Iredell-Statesville Schools
WAN Connectivity - Request for Proposals (RFP)
FY 2027 E-rate Form 470 Application # 270000665

Wide Area Network (WAN) Connection For Two New Construction Schools

APPENDIX A
SCHOOL SITE PLANS AND FLOORPLANS

1 SITE PLAN
1" = 40'-0"

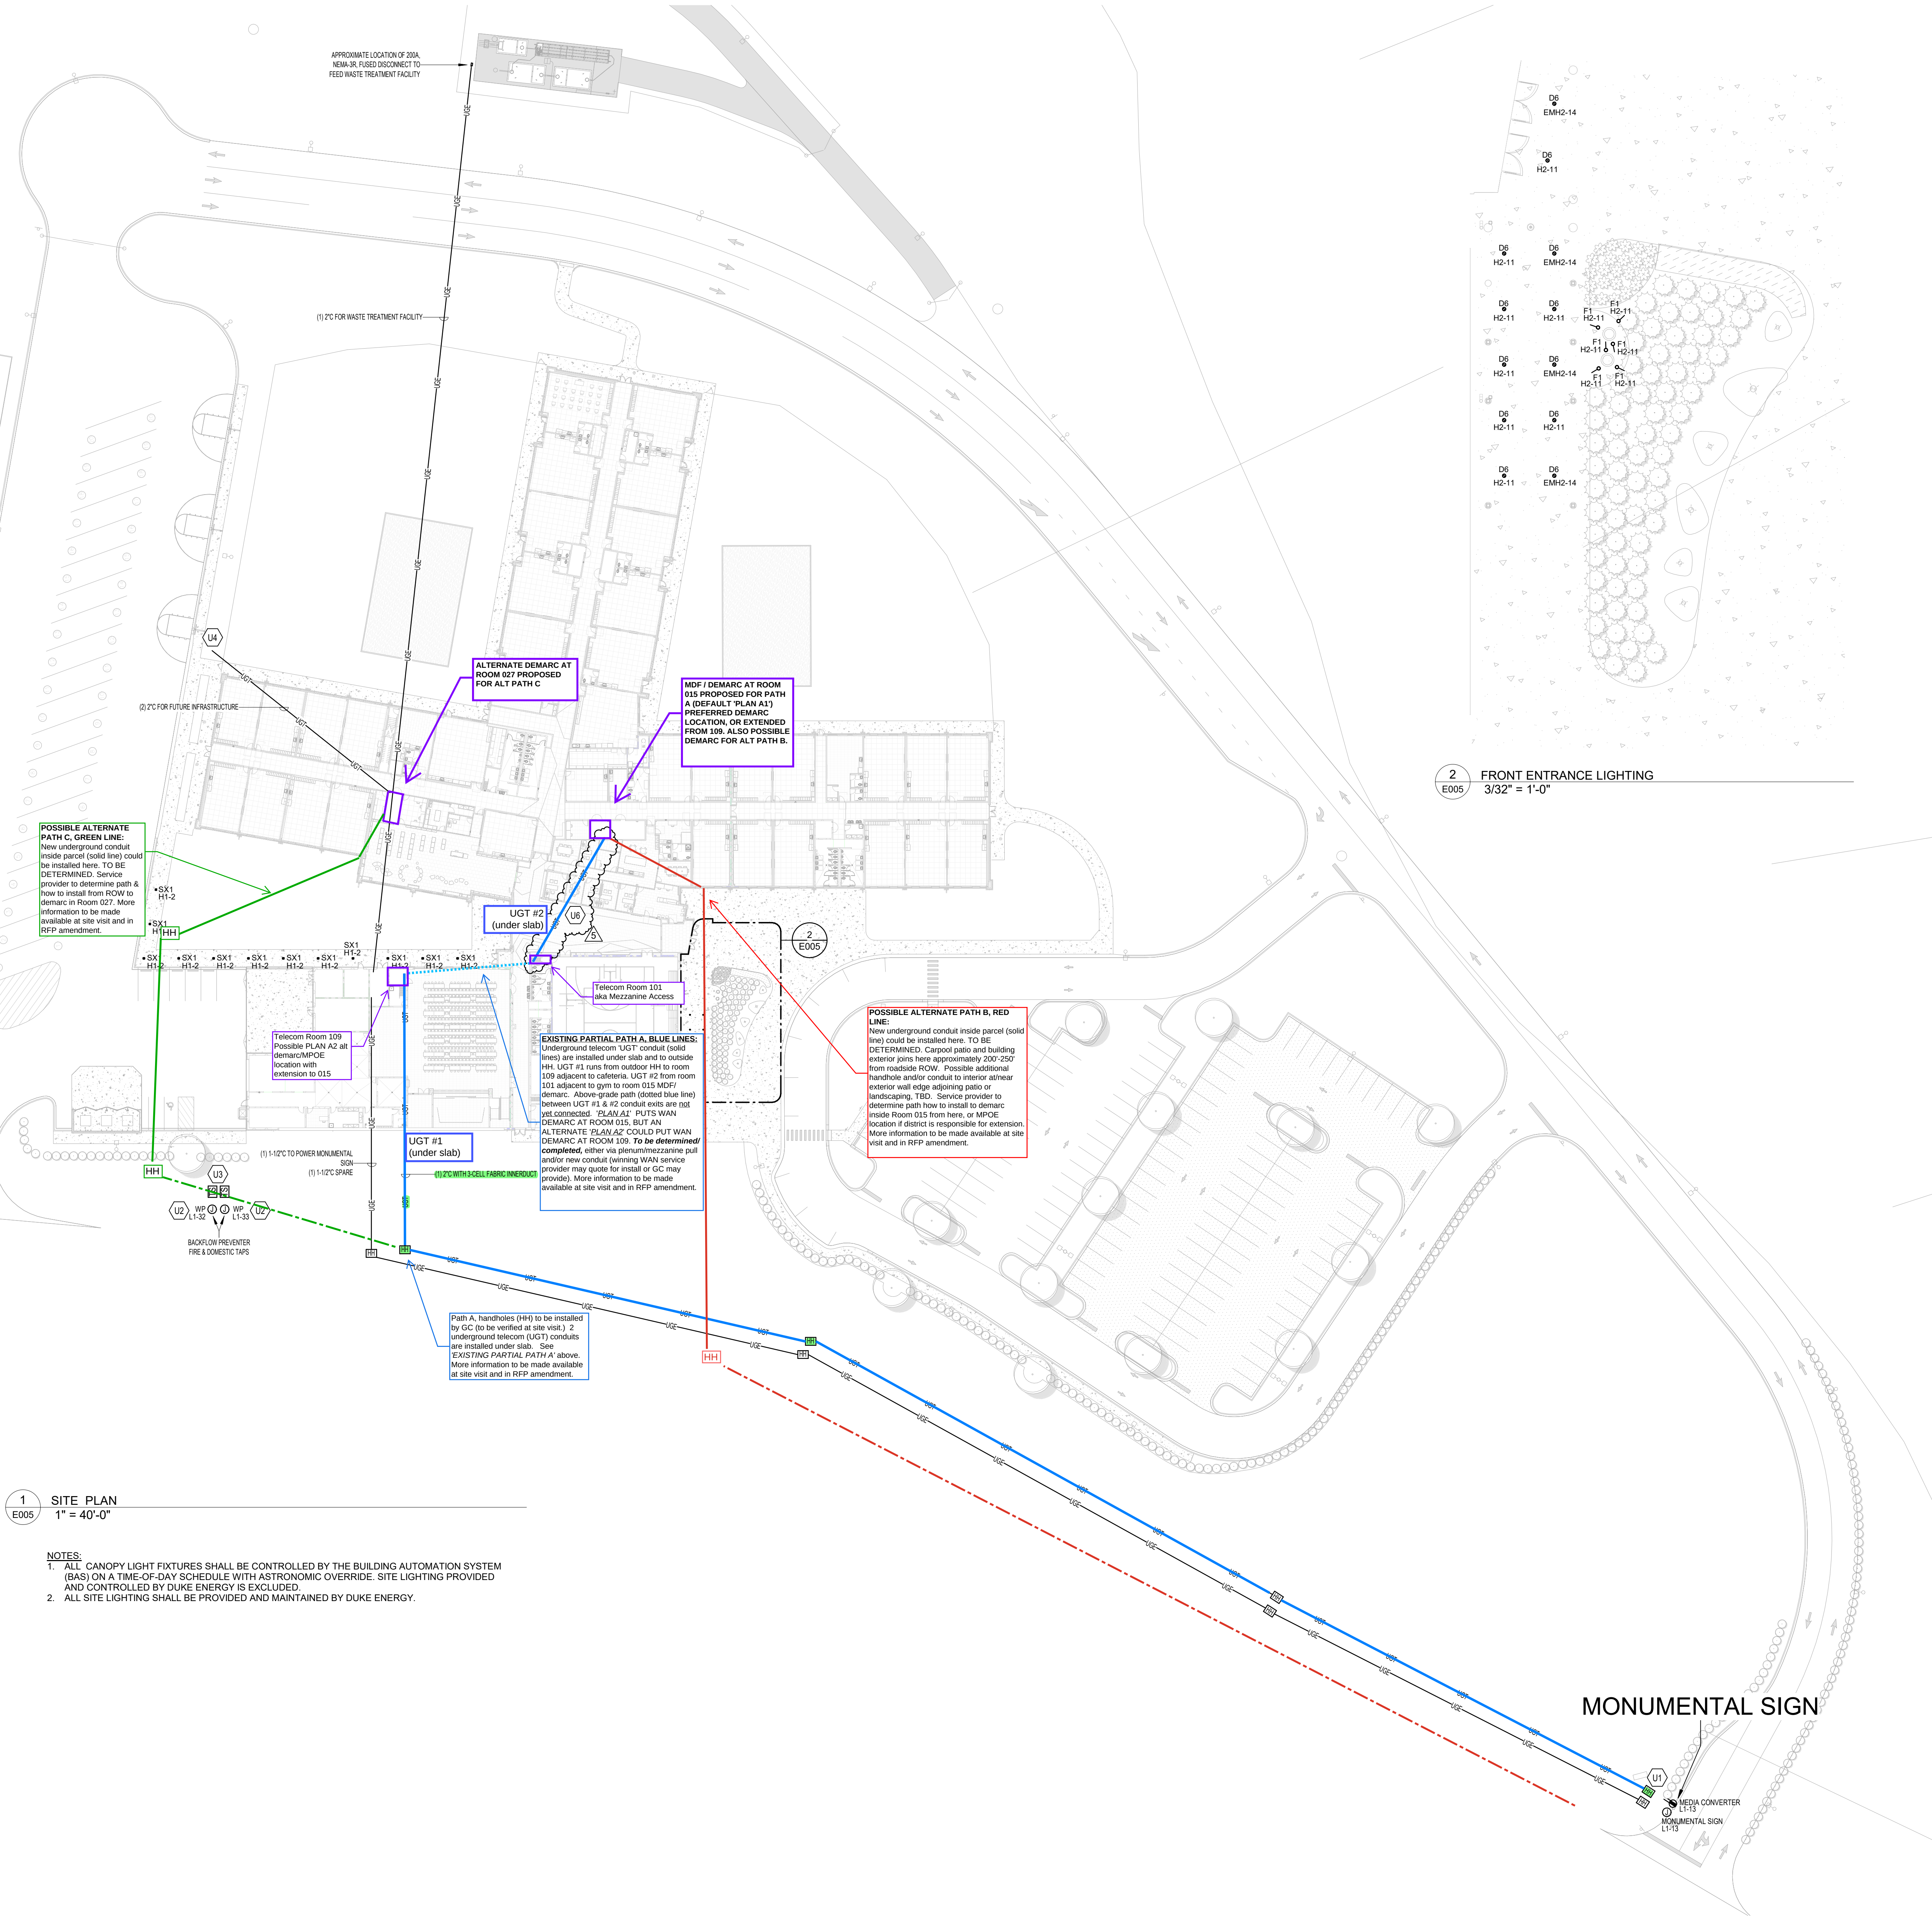
Because concrete slabs were poured more recently at this school than at WCHS, not all buildings/wings are yet constructed as of the release date of this RFP. Progress will probably be made by the time of the site visit, but there are 3 proposed paths shown in different colors from ROW (HH = handhole) to demarc, one of which is proposed by the architect in BLUE and is partially constructed, however it will require clarification by the time of the scheduled site visit. Additional paths in RED and GREEN will be considered or additional options may emerge by the end of the site visit or RFP addendum posting. Note that PURPLE boxes indicate possible MDF/demarc locations or telecom closets/rooms along the path. Potential paths (and possible plans) as of this writing include:

- A. EXISTING PARTIAL PATH A, BLUE LINES - The underground telecom 'UGT' conduit (solid BLUE lines) are installed under the slab and to outside handholes (HH). UGT #1 at the bottom from the ROW runs from outdoor

HH to room 109 adjacent to the cafeteria. UGT #2 begins in room 101 (Mezzanine Access or 2nd telecom room on this path) adjacent to the gym and runs under the slab to room 015 MDF/"preferred" demarc. The above-grade path (dotted blue line) between UGT #1 & #2 conduit exits are not yet connected. ISS district staff assume from the GC that this will be accessible via the mezzanine (not yet constructed). 'PLAN A1' would put the WAN demarc at room 015, with responsibility for maintenance to the demarc on the service provider. But an alternate 'PLAN A2' would put the WAN demarc/MPOE at room 109 instead. This is still to be determined. In either case the full install or extension via plenum/mezzanine pull and/or new conduit (winning WAN service provider may quote for install or GC may provide). More information to be made available at site visit and in the upcoming RFP amendment.

- B. POSSIBLE ALTERNATE PATH B. RED LINE: If providers determine Path A to be impractical or not workable, the district will entertain an option for a new underground conduit (solid red line) installed from the ROW to the building edge along the carpool patio edge at the building exterior shown. Demarc is preferably the same Room 015 as before or by extension from MPOE at or near exterior wall entry. Expect approximately 200'-250' from roadside ROW to building entry. Additional handhole location and/or conduit to interior at/near exterior wall edge adjoining patio or landscaping may need to be determined. ISS district staff believe concrete may not be poured for a while at this location. Service providers may ask for additional information at site visit or check the RFP amendment the day after the site visit.

- C. POSSIBLE ALTERNATE PATH C. GREEN LINE: A third pathway option might instead be new underground conduit on the opposite side of the school as PATH B, entering at or near the media center. This path is also to be determined but would likely require at least 2 handholes (HH in green) near the bus lot as shown at left in the drawing. Service provider to determine how to install from ROW to demarc in Room 027. This may hypothetically assume that the MDF moves to 027, or the district bridges this room to 015 via its own fiber run patch. Clarifications and more information to be made available at site visit and in the RFP amendment.
